TRI-STATE GENERATION AND TRANSMISSION ASSOCIATION, INC.
HEADQUARTERS: P.O. BOX 33695 DENVER, COLORADO 80233-0695 303-452-6111

RE: Colowyo Coal Company L.P.
Permit No. C-1981-019
Technical Revision No. 143
Reclamation Plan & Tall Shrub Field Trials

CHANGE SHEET FOR PERMIT REVISIONS, TECHNICAL REVISION, AND MINOR REVISIONS

Revision Description: **TR-143 Reclamation Plan**

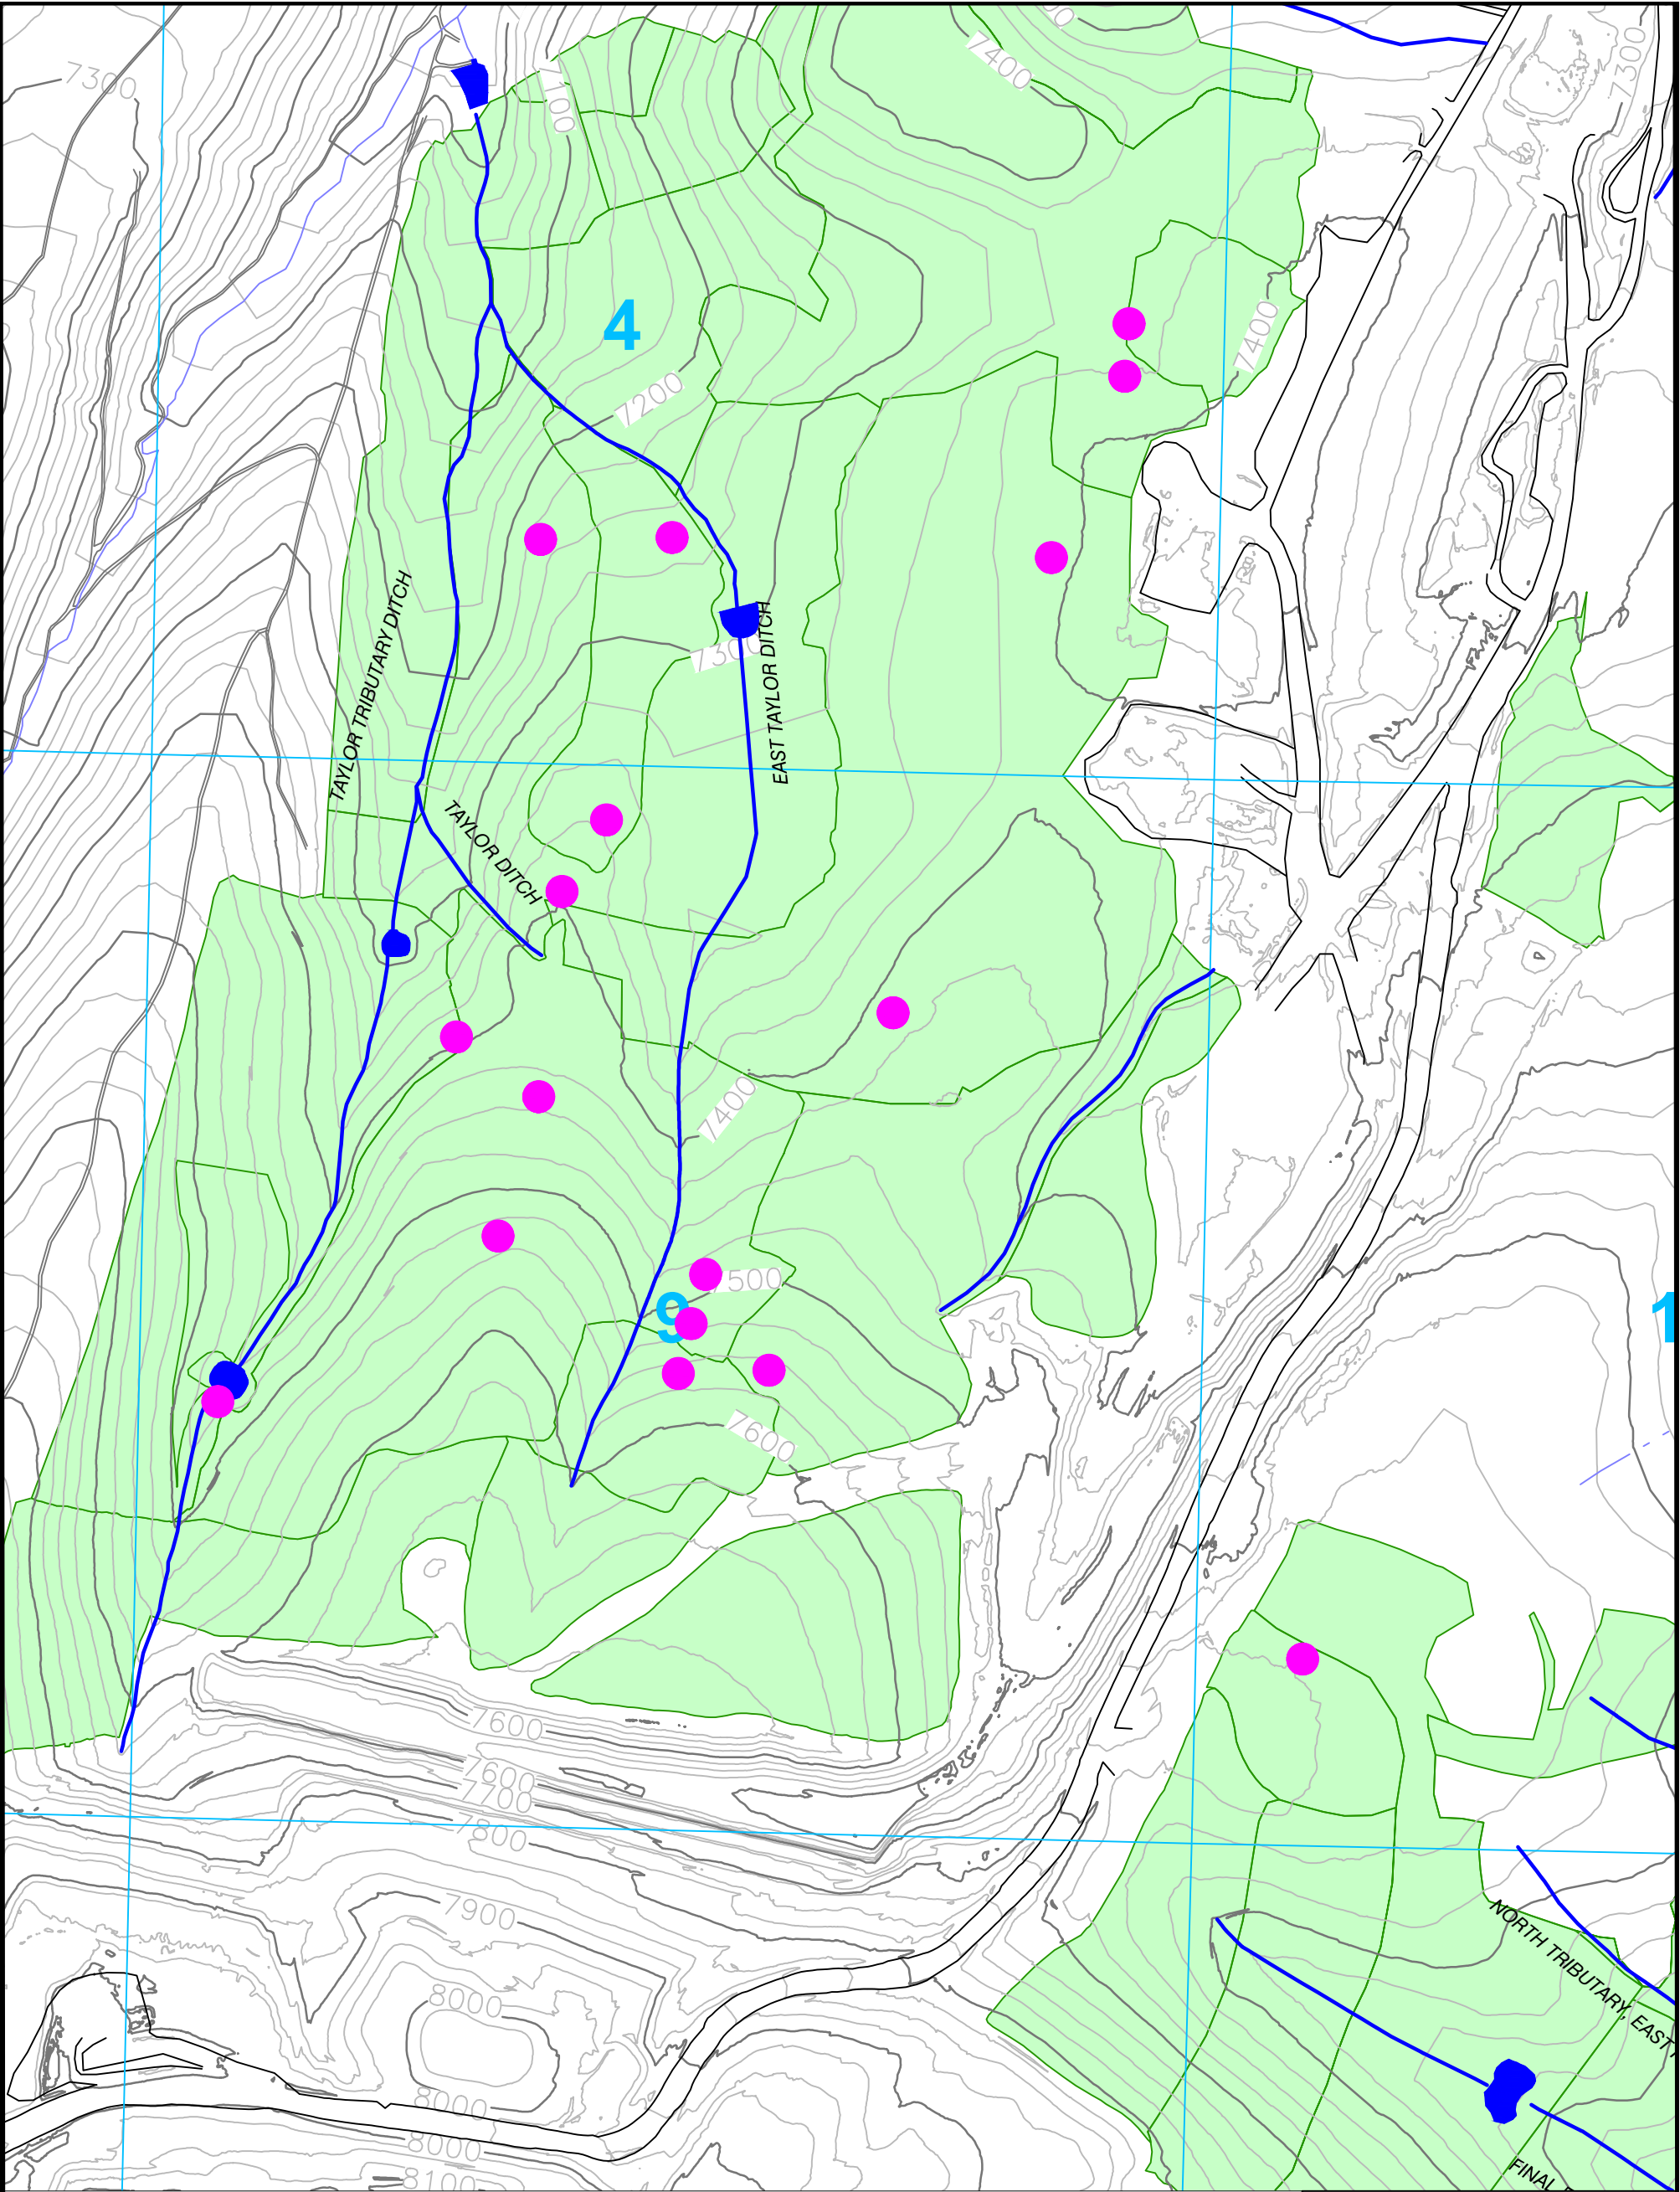
* Should one or more of the species in Table 2.05-7 be unavailable or proven ineffective, then substitutes from this list will be selected in the priority stated. They will be placed in the seed mix at the rate specified in the priority stated. They will be placed in the seed mix at the rate specified for the unavailable/unsuitable species or as appropriate. If more than one species of a given lifeform cannot be obtained or is otherwise unsuitable, then the first and second priorities in the substitute list will be used. Colowyo can also choose to increase a seeding rate of an approved species if a corresponding substitute is not available rather than choose a substitute from Table 2.05-9. Colowyo will obtain prior verbal approval from the CDRMS.
